City of Pompano Beach
100 W. Atlantic Boulevard
Pompano Beach, FL 33060

**Re: Plan Review – Costco PZ25-12000023
Comment-Response Letter**

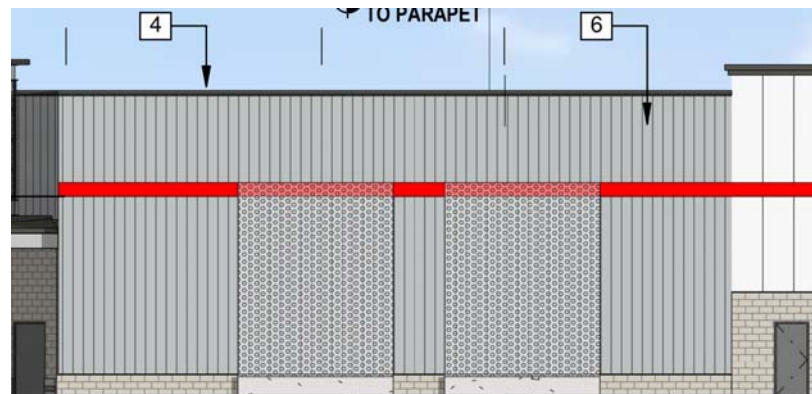
- ii. Columns or pilasters that are at least eight inches deep and at least eight inches wide, and have a height equal to at least 80 percent of the facade's height;

iii. Roofline changes that vertically align with a corresponding wall offset or change in facade color or material, including changes in roof planes and changes in the height of a parapet wall (such as extending the top of pilasters above the top of the parapet wall); or

Response: Understood.

Response: Understood
